Application No.: A.15-09-013  
Exhibit No.: SDGE-13  
Witnesses: Douglas M. Schneider  
David M. Bisi  
Sharim B. Chaudhury  
Paul Borkovich  
S. Ali Yari  
Allison Smith  
Deanna Haines  
Travis Sera  
Norm G. Kohls

**REBUTTAL TESTIMONY**  
**OF**  
**SAN DIEGO GAS & ELECTRIC COMPANY**  
**AND**  
**SOUTHERN CALIFORNIA GAS COMPANY**

**BEFORE THE PUBLIC UTILITIES COMMISSION  
OF THE STATE OF CALIFORNIA**

June 12, 2017

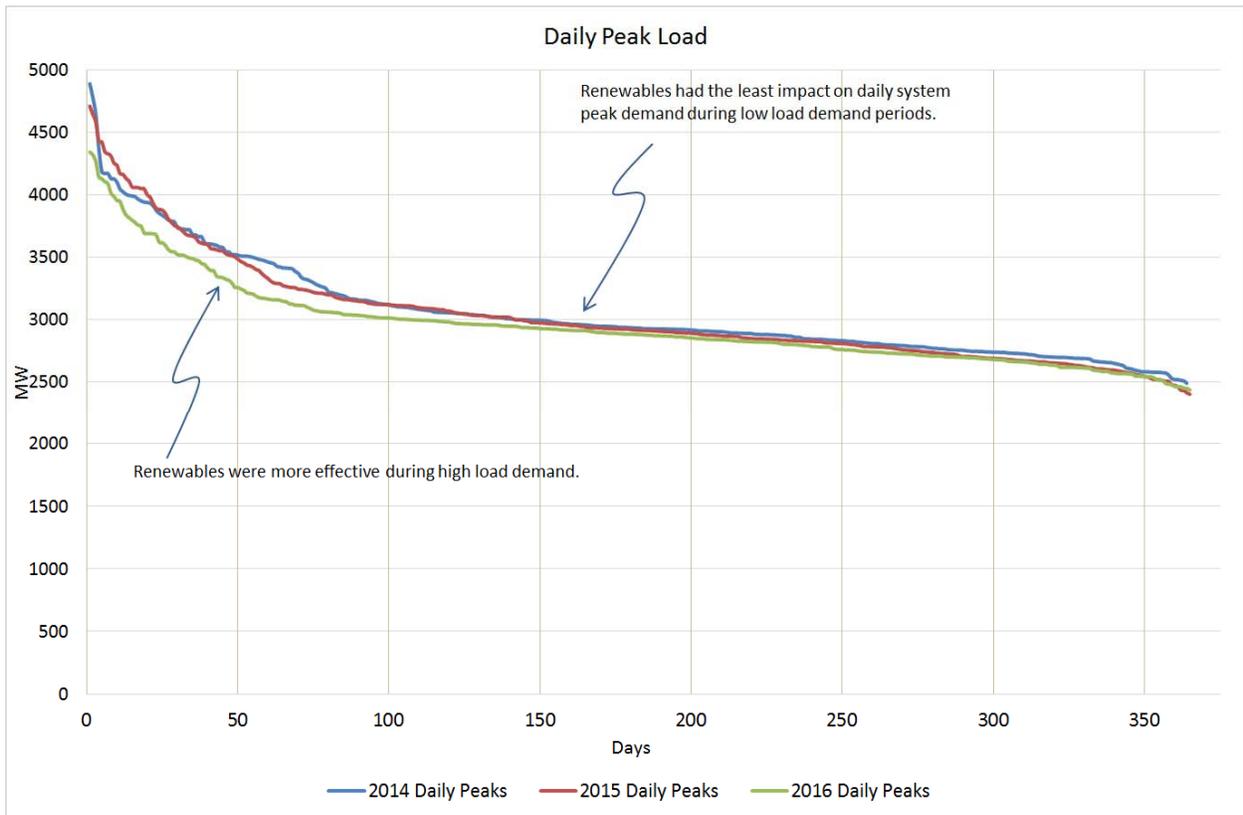
16 After a thorough evaluation of SCGC’s Figure 7 and Figure 11, it appears SCGC created  
17 these illustrations without any supporting statistical data or technical analysis. The graph is  
18 simply created by shifting the 2014 Daily Peak Load graph down to the amount of the projected  
19 peak load in the year 2026. Further, in Figure 7 and Figure 11, SCGC incorrectly illustrates that  
20 load demand for each day would decrease incrementally by the same amount. Figure 7 and  
21 Figure 11, the Daily Peak Load Graph, is not a straight line linear relation.
